## REMARKS

ANNOTATED MARKED-UP DRAWINGS

FIG. 1

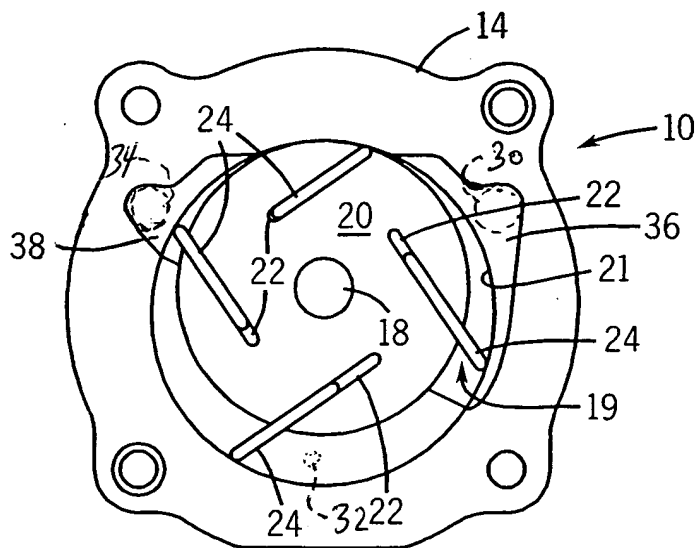
The above action indicated that the drawings were objected to because of the issues raised in the first three paragraphs of page 2. In particular, the drawings were objected to because ports 30, 32 and 34 were not shown in Figure 1, and reference numerals 40, 42, 56, 58, 60, 62 and 64 were not shown in Figure 3. Also, the drawings did not show the filter element recited in the claims.

The enclosed drawing sheets titled "Annotated Marked-up Drawings" include proposed changes to Figures 1, 3 and 4 shown in red to add the noted reference numbers to Figures 1 and 3 and to add a filter --74-- to Figure 4. A new set of formal drawings is also enclosed with each sheet titled "Replacement Sheet".
